Item Name: Replacement Skidtube (Fits LH or RH)

DRAWING NO. D2650	TITLE 206/407 SKIDTUBE ASSEMBLIES	REV. F	DART AEROSPACE LTD ENGINEERING ORDER		D.E.O. NO. D2650-F-1	SHEET NO. SHEET 1 OF 1	SCALE NTS
DRAWN <i>[Signature]</i>	CHECKED A.P.	MFG. APPR. <i>[Signature]</i>	APPROVED <i>[Signature]</i>		DE APPR. <i>[Signature]</i>		
DATE 12.10.12	DATE 12.10.22	DATE 12.10.22	DATE 12.10.22		DATE 12.10.22

CHANGE C'BORED WELDED CROSSBOLT SPACERS TO SWAGED SPACERS

DETAIL G

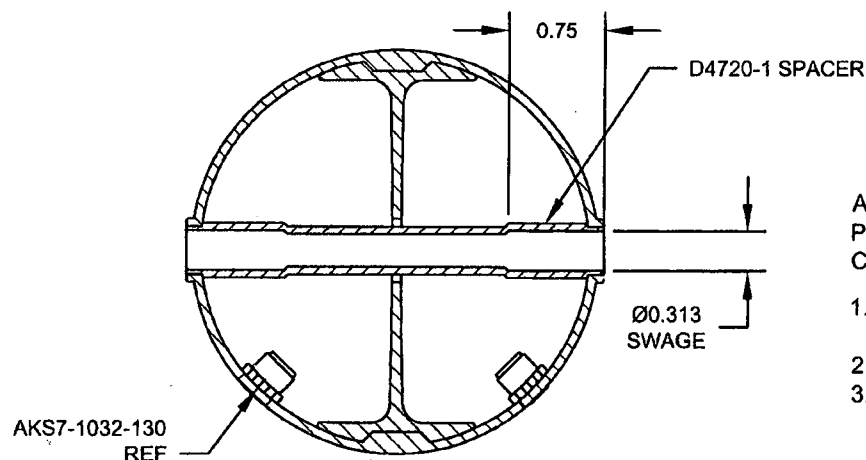
ADD DETAIL G BELOW, WHICH IS THE SAME SECTION VIEW AS DETAIL D OF DWG.

C'BORED HOLES ARE **NOW SWAGED** PER DETAIL G BELOW. FOR THE Ø0.375 HOLE THAT IS NOT C'BORED, WELD PER DETAIL D OF DWG (SEE AMENDED DETAIL B FOR REFERENCE).

AFTER DRILLING AND BENDING ASSEMBLY
PERFORM THE FOLLOWING FOR Ø0.375 HOLES THAT ARE
CURRENTLY C'BORED:

1. INSERT D4720-1 SPACER, 16 PL (-1) OR 17 PL (-3)
OR 19 PL (-5) OR 23 PL (-7)
2. SWAGE TO Ø0.313 X 0.75 DP PER QSI 002
3. TRIM / GRIND FLUSH PER QSI 002
